U.S. NUCLEAR REGULATORY COMMISSION
REGION I

Report No.: 50-213/96-80

Facility: Haddam Neck Station

Haddam Neck Station
NRC Inspection Report No. 50-213/96-08

Figure 1

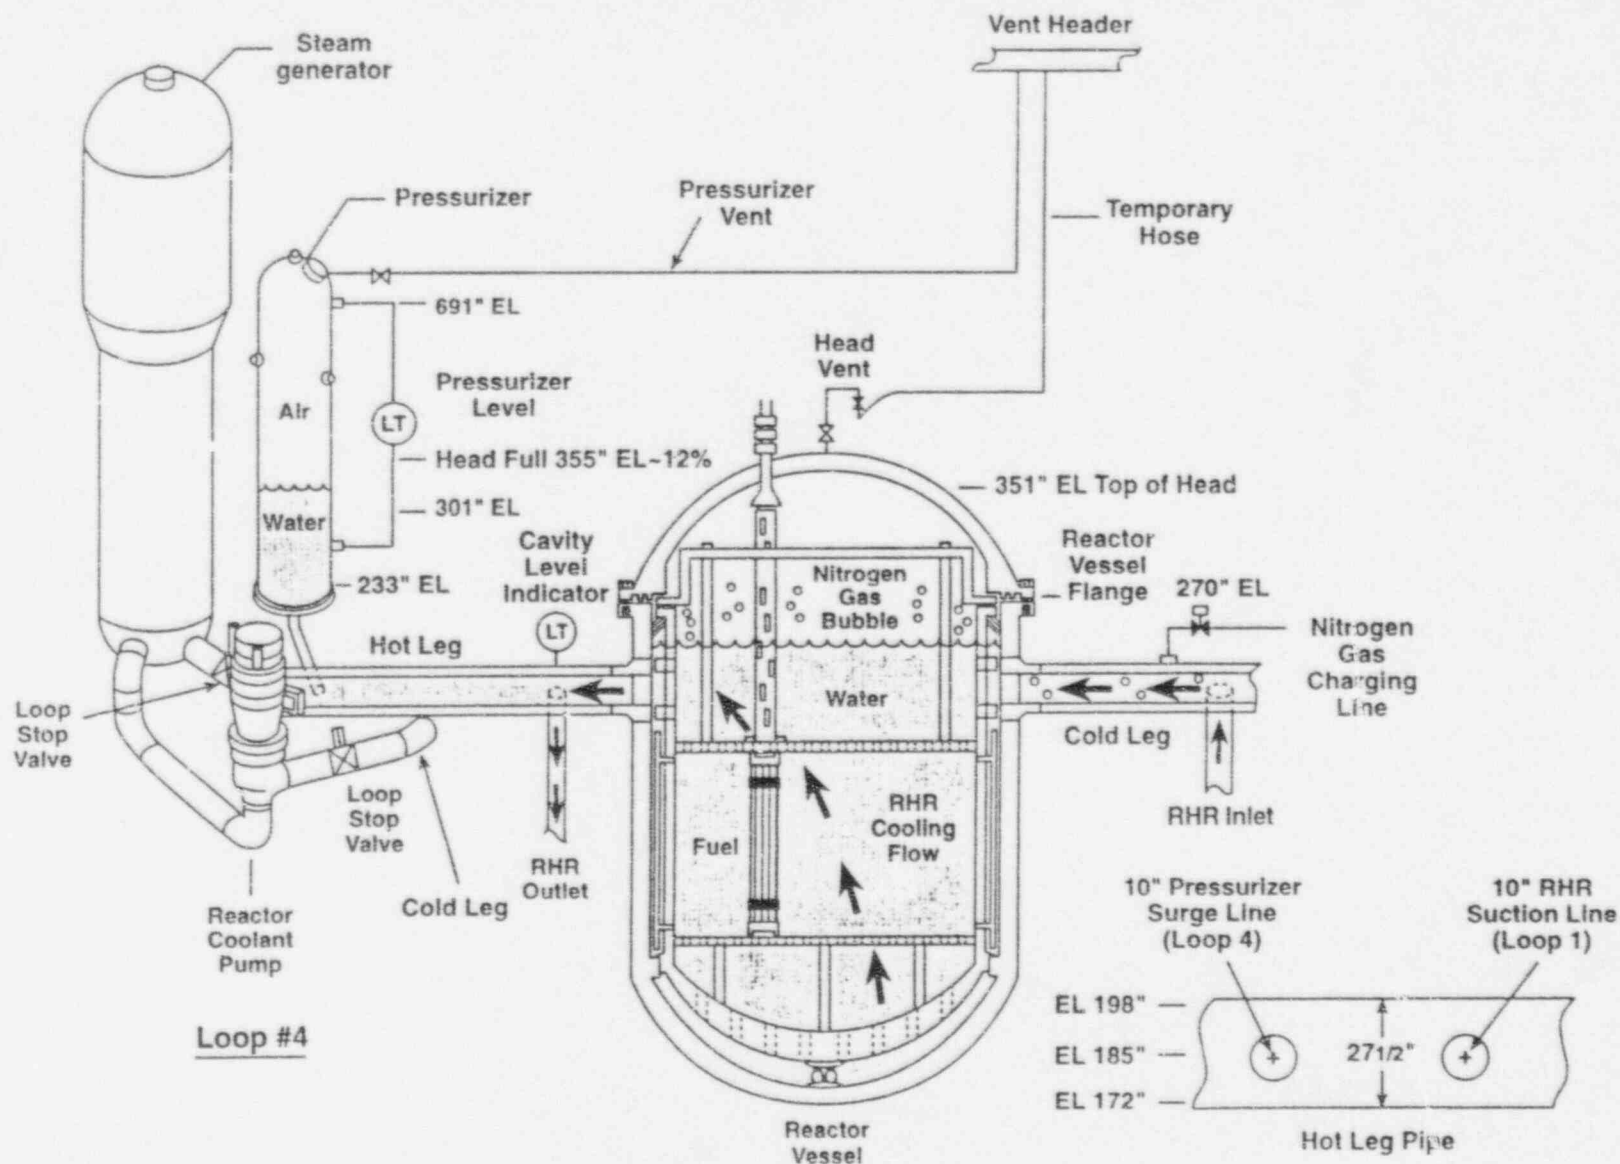
The RCS was depressurized and the vent header system was in service. The vent header system was connected to the reactor vessel head using a temporarily installed hose. The vent header system maintains a small vacuum to remove gasses from the RCS (See Figure 1 of this report).

Figure 2

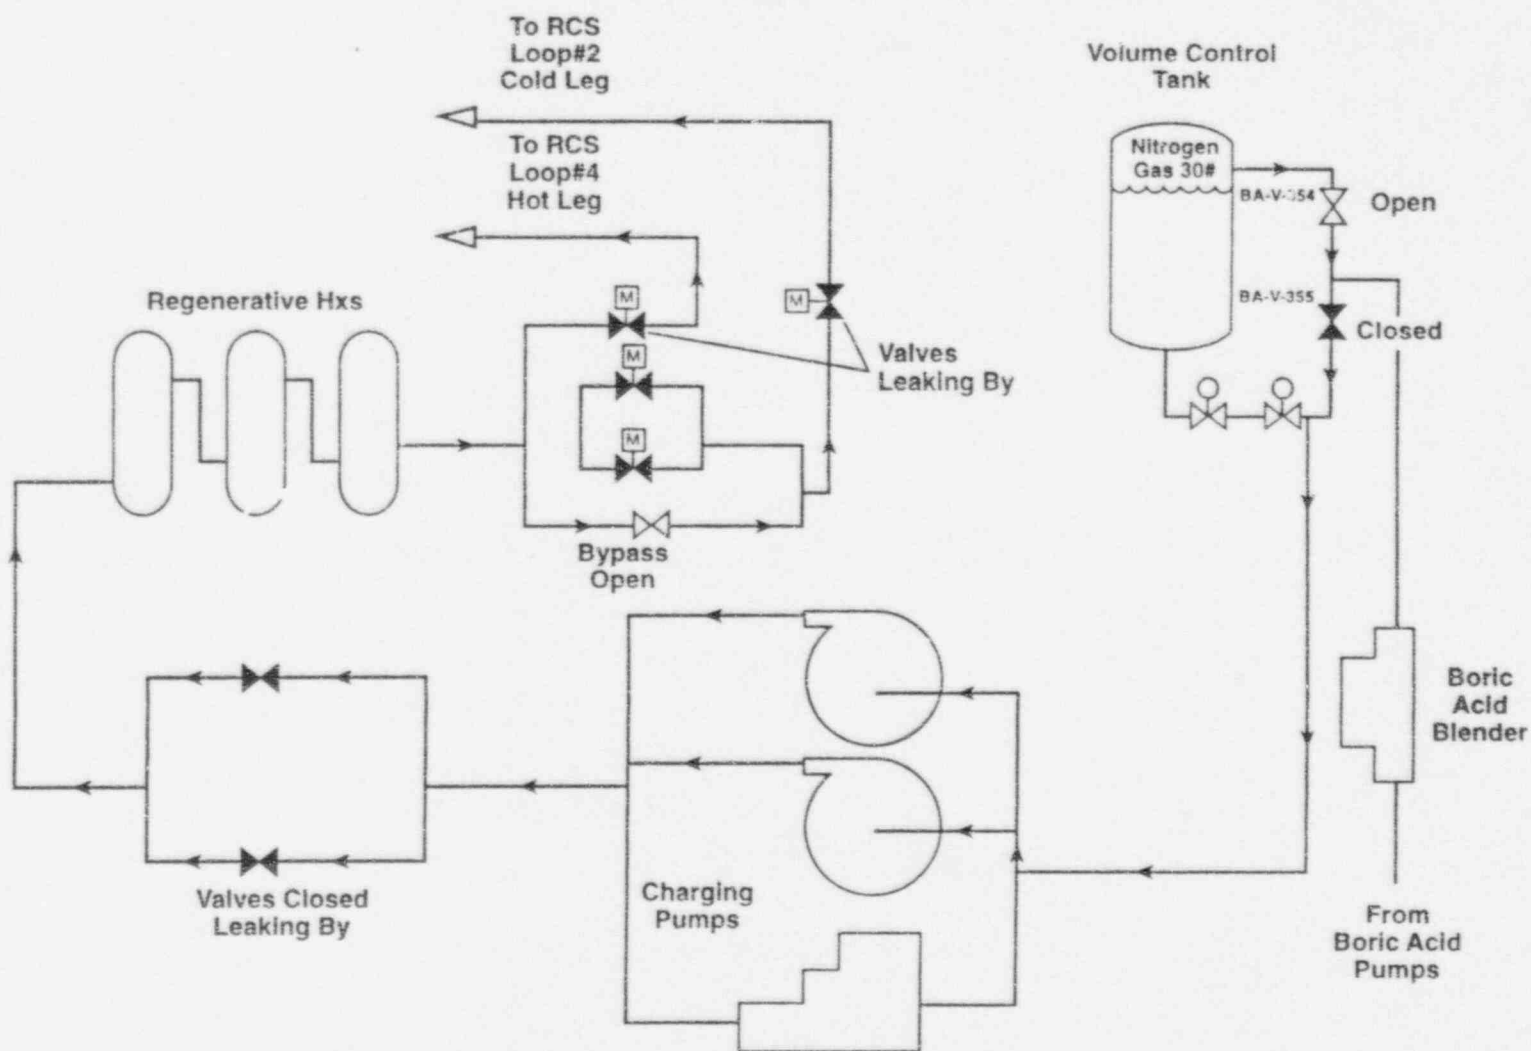
On August 28, 1996, nitrogen gas from the VCT began to enter the reactor vessel (See Figure 2 of this report). A Nuclear Systems Operator (NSO) was in the process of realigning certain CVCS valves to establish a new boric acid flow path. During this evolution, the NSO inadvertently opened the wrong manual valve (BA-V-355). This error caused water and nitrogen gas from the CVCS system to enter the RCS. Control room operators noticed an increase in RCS level and promptly instructed the NSO to reclose the valve. Closing the valve should have stopped the nitrogen gas from entering the RCS; however, the valve failed to fully close and nitrogen gas continued to leak into the RCS. Nitrogen gas continued to flow through the idle charging pumps and several leaking valves into the reactor vessel. The nitrogen gas accumulated in the top of the reactor vessel head. The rate of addition of nitrogen gas exceeded the removal capacity of the vent header system. Therefore, a nitrogen gas bubble began to grow in the top of the reactor vessel. The water displaced by the gas bubble was forced out of the reactor vessel and into the pressurizer. The transfer of water inventory from the reactor vessel to the pressurizer resulted in a decrease in reactor vessel level.

Figure 3

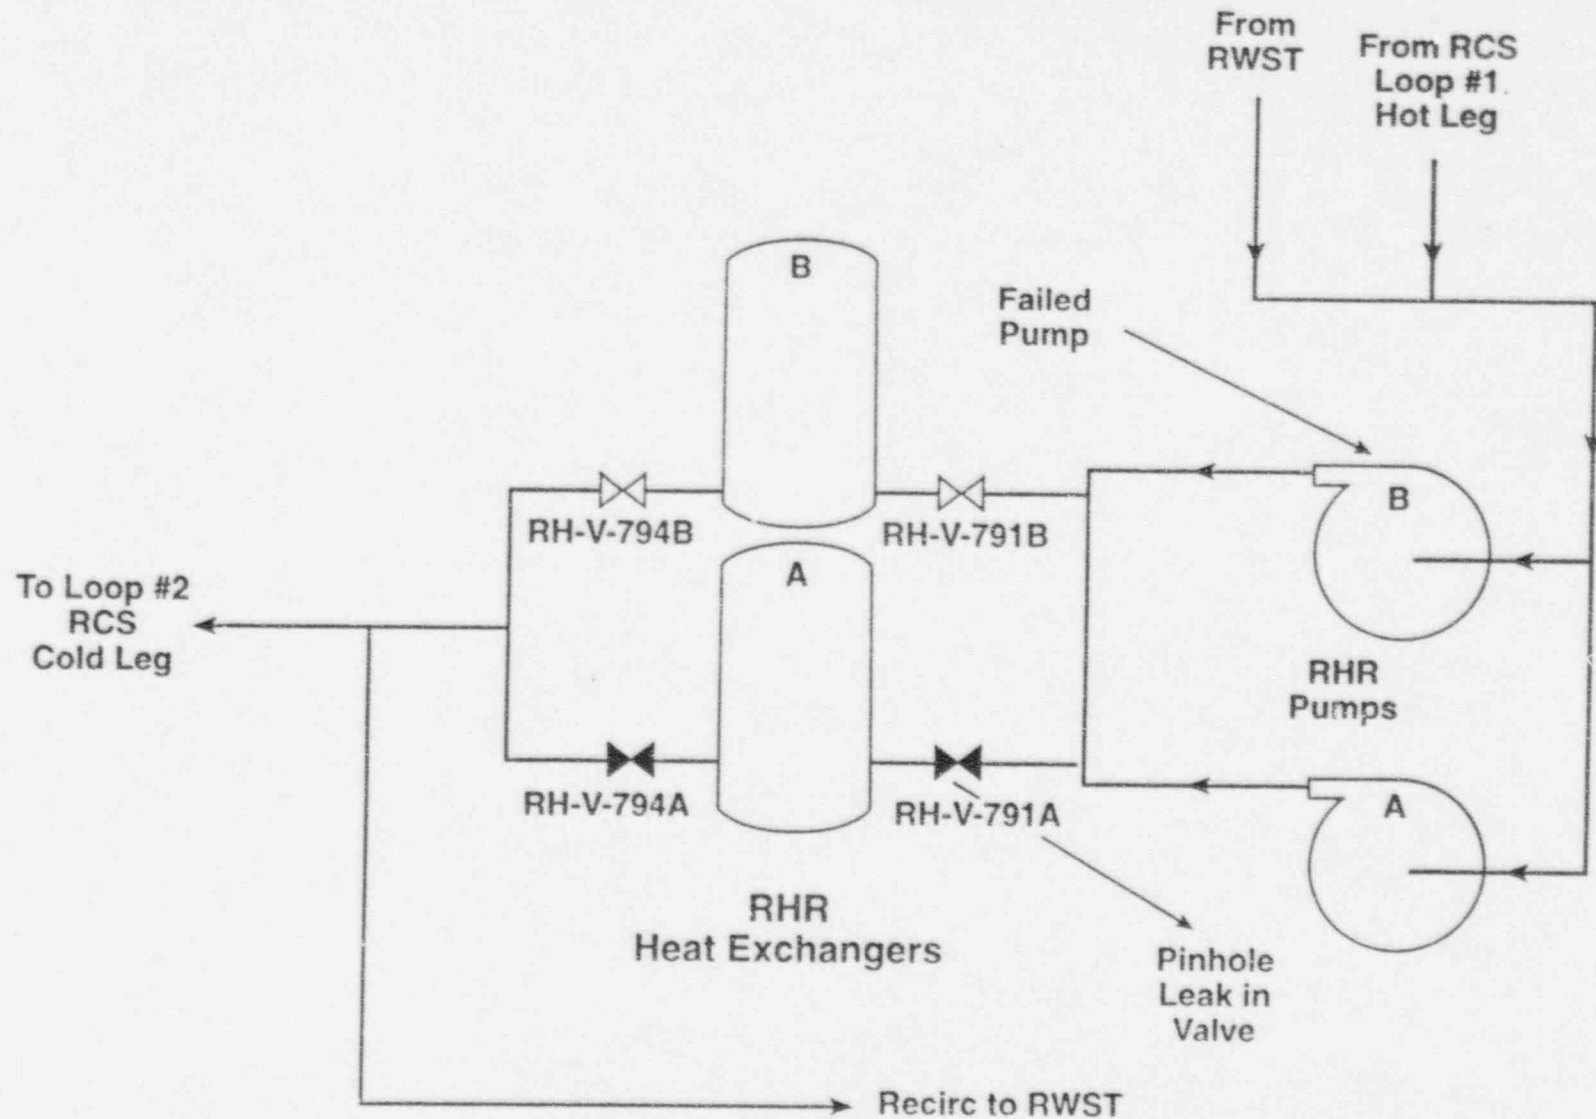
The RHR system is used to remove decay heat from the fuel when the reactor is shutdown. The system is designed such that a single failure, of certain components, will not prevent the system from performing its decay heat removal function. At the same time there was a nitrogen gas bubble in the reactor vessel, one redundant RHR pump and heat exchanger were not available for service (See Figure 3 of this report).
